**3 Position Rotary Switch wiring configurations - Applies to all Pop-Up machines with internal chargers fitted**

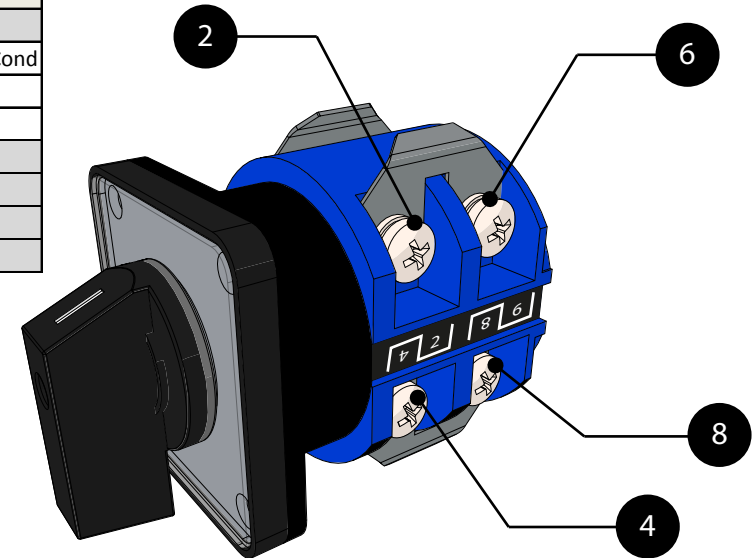
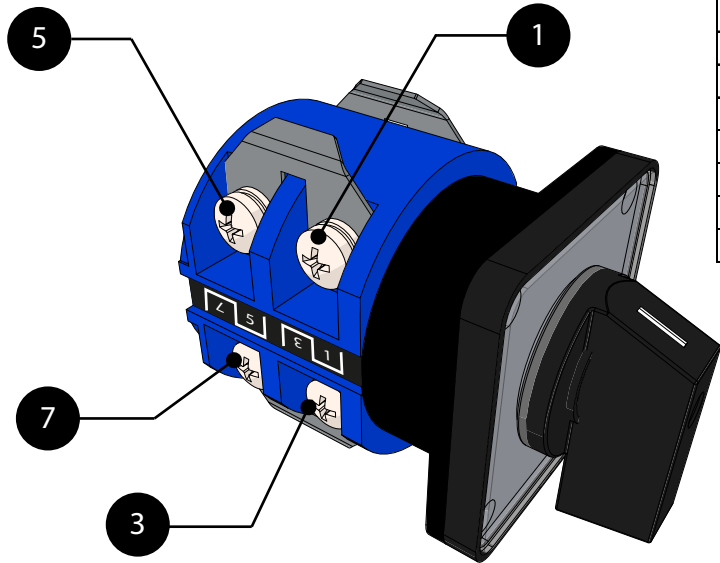
Due to the change of the 3 position switch on Eco 6 & 8 machines, replacement switches for all Pop-Up and Pop-Up+ machines will have slightly different wiring schemes for this switch.

Please follow the wiring schemes laid out in the tables above. Main switch illustrations show terminal layouts as found on all types of switch.

Terminal	Terminal Functions		
	Original Switch	Type I	Type II
1			
2	Linked to 4		Output / Batt Cond
3	Charger	Input	Input
4	Linked to 2	Charger	Charger
5	Output	Output / Batt Cond	
6	Input		
7			
8

*Note: Remove any link wire and use link plates as shown in the illustrations above*
